7204
09/020,699
Art Unit 2187

REMARKS

This Amendment is submitted in response to the Final Office Action mailed on November 7, 2000. Claims 1, 2, and 4 - 20 are pending. All are allowed, except claims 14 - 16, which are rejected.

FIG. 1

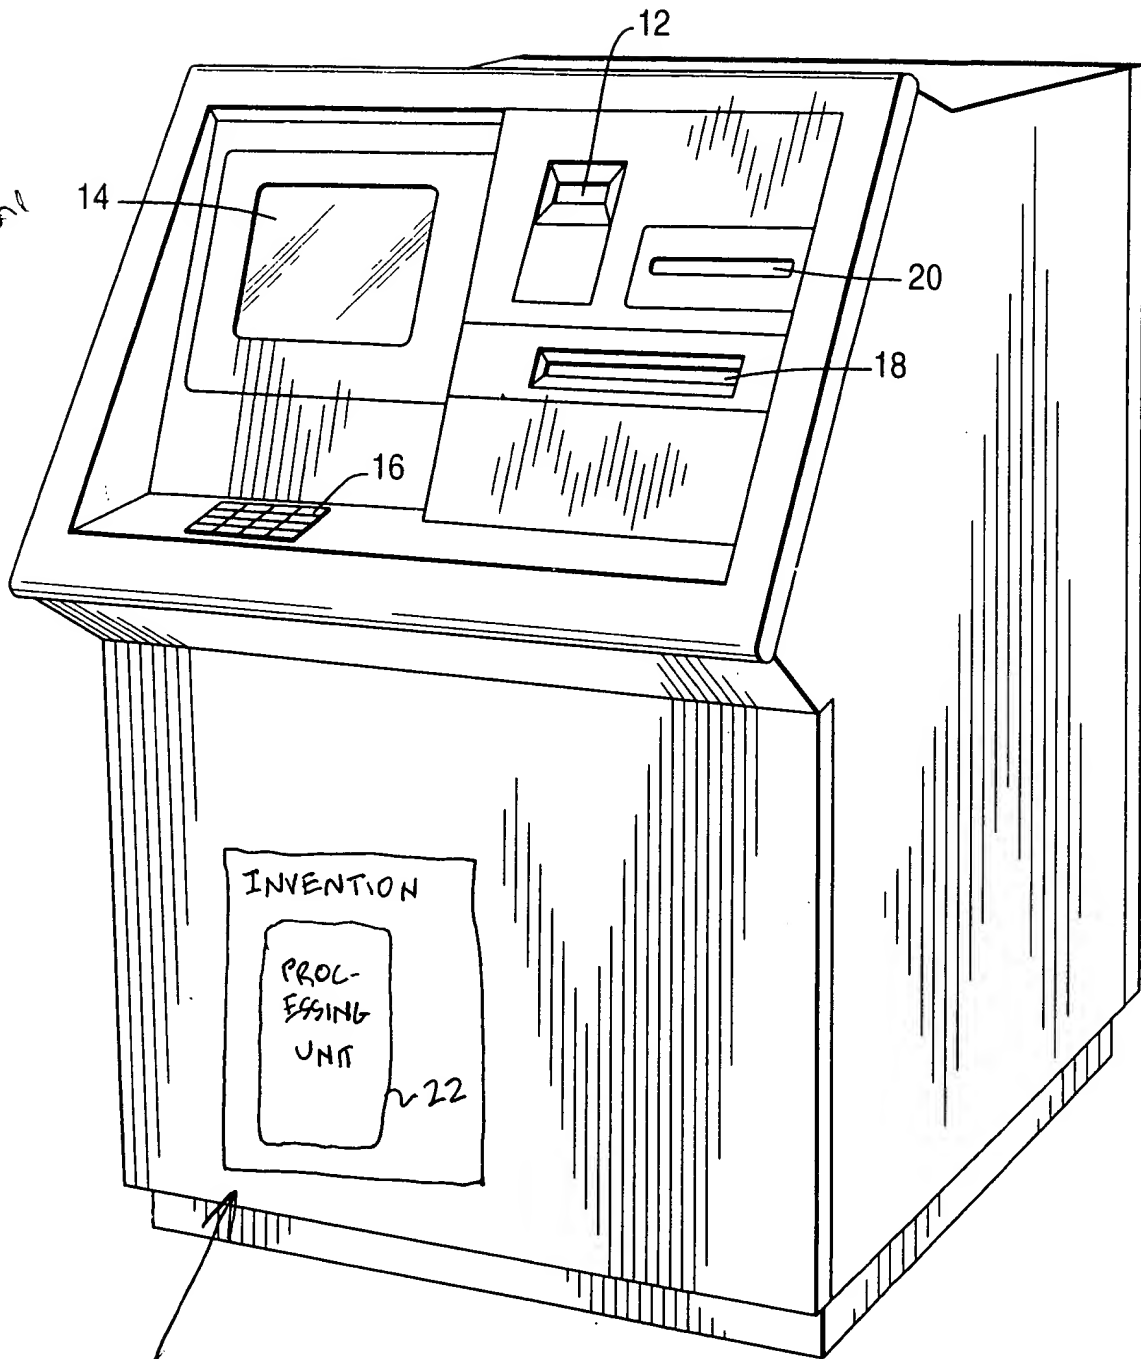
Applicants request that the objection to Figures 1 and 2, on the grounds of lacking the legend "Prior Art," be reconsidered and withdrawn. The reasons were stated in the Brief, and are repeated here.

Explaining this in greater detail, the objection appears to mistake **appearance** for **substance**. The **housing** shown in Figure 1 may appear within the prior art. However, labeling Figure 1 as "prior art" acts as an admission that the **machinery** within that housing is within the prior art. That is not so: the Specification states that the **machinery** includes the present invention. Applicants cannot admit a falsehood.

Applicant offers to resolve this apparent problem by the enclosed PROPOSED DRAWING AMENDMENT, which adds a graphical block to Figure 1, within the ATM 10, which is labeled "invention." Support for that block is found in the Specification, as described in the preceding section.

Do. Not
enter
RFE
7/29/2011

PROPOSED
DRAWING
AMENDMENT
